PLANNING COMMISSION AGENDA

Title: PUBLIC HEARING - Conceptual Site Plan Amendment, The Hive Development at 555 North 400 West - ADMINISTRATIVE DECISION

APPLICATION: **SITE PLAN AMENDMENT – CONCEPTUAL SUBMITTAL**

SHEET NO. **C5.2**

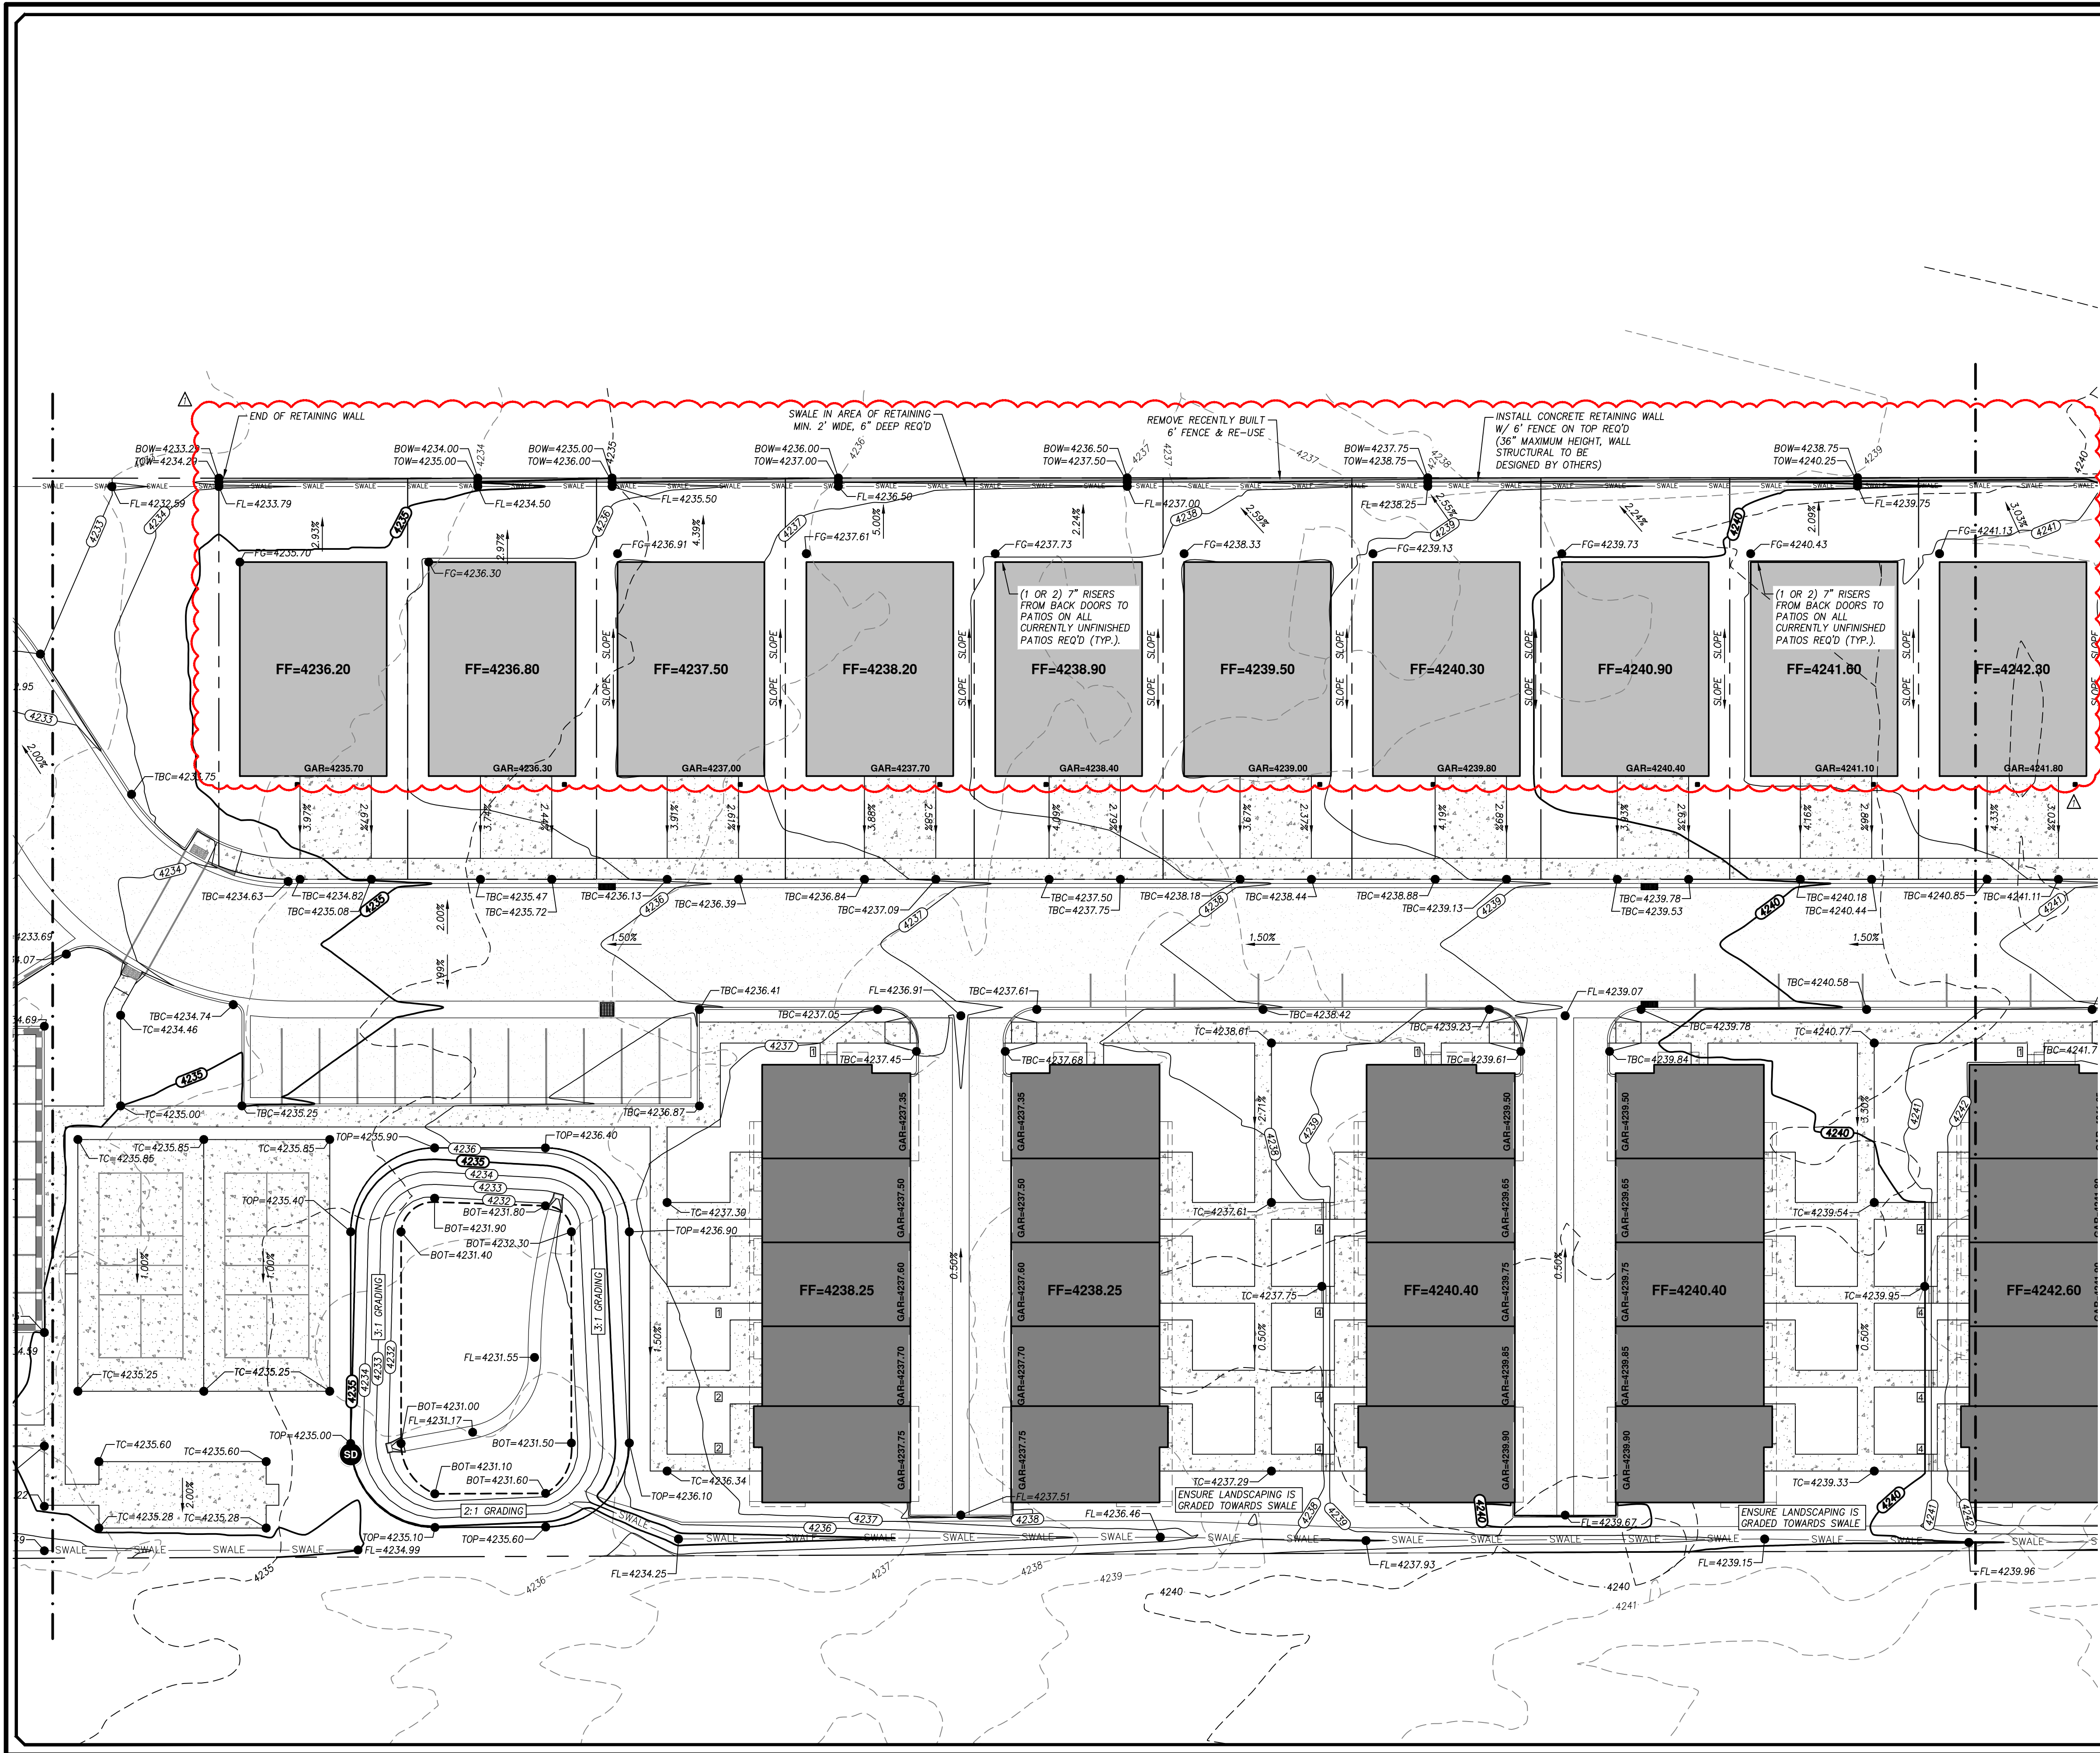
The Applicant desires to amend their Site Plan Approval regarding fencing along the northern property line. Due to final site grading along the single-family lots, the desire now is to add a 1' to 3' retaining wall, and then install the approved 6-foot fence on top of the retaining wall. This final height of the fence would then range from 7-feet to 9-feet.

According to the submittal, the current grade of the backyards for the new homes is higher than originally planned. Consequently, the homes will site a bit higher in elevation, which is measured from the final finished grade. If the final grade of the rear line of the new home lot remains the same, it increases the down slope of the back yard due to the short 20-foot setback. If the grade is not transitioned with this increased slope (e.g. owners wanting a flatter yard area), it creates a channeling/canal like structure along the back yards in order to drain the yards areas, as originally planned. The applicant would like to mitigate this problem by installing the retaining system.

The design plan is to keep the drainage plan along the rear yards as originally designed. Additionally, the applicant has represented to staff that the downspouts for roof drainage will be connected to the stormwater system in the private lane in the project. Therefore the rear yard system will only carry stormwater generated from the rear yards.

Furthermore, the applicant makes the argument, that the taller fence will slightly increase the visual buffering for the existing homes located to the north. However, this taller fence may create additional sunlight shadowing of the rear yards for existing homes to the north. Nevertheless, the increase fence height will assist in buffering the new development in this higher density zone that is adjacent to the residential low zone to the north (see CZC 12.55.110(4)(B)).

1. The proposed increased fence height of 1' to 3' shall be limited to the submitted plans depicted on Sheet C5.2 and C5.3, Grading Plan – Amended and the Retaining Wall System designed by Focus Engineering & Surveying, LLC, dated August 24, 2022.
2. However, the fencing shall be reduced/limited to the allowable 48-inch height in the front yard setback area of 400 West – See CZC 12.55.110(b) – missed labeled/typed as (a).

3. *This accepted amendment to the fencing, retaining, and drainage plan shall be reviewed and deemed acceptable, by the City Engineer, for compliance with applicable ordinances and codes adopted by the City.*
4. *This accepted amendment to the fencing, retaining wall system, and the drainage plan may be modified in compliance with the City Engineer's recommendations, provided however, the modification does not exceed the proposed 1'-3' increase in height.*
5. *A building permit for the fencing and retaining wall system shall be submitted and obtained from the City's Building Division, subject to approval by the Building Official.*
6. *This accepted amendment to the fencing and retaining wall system may be modified in compliance with the City Building Official's recommendations, provided however the modification does not exceed the proposed 1'-3' increase in height.*
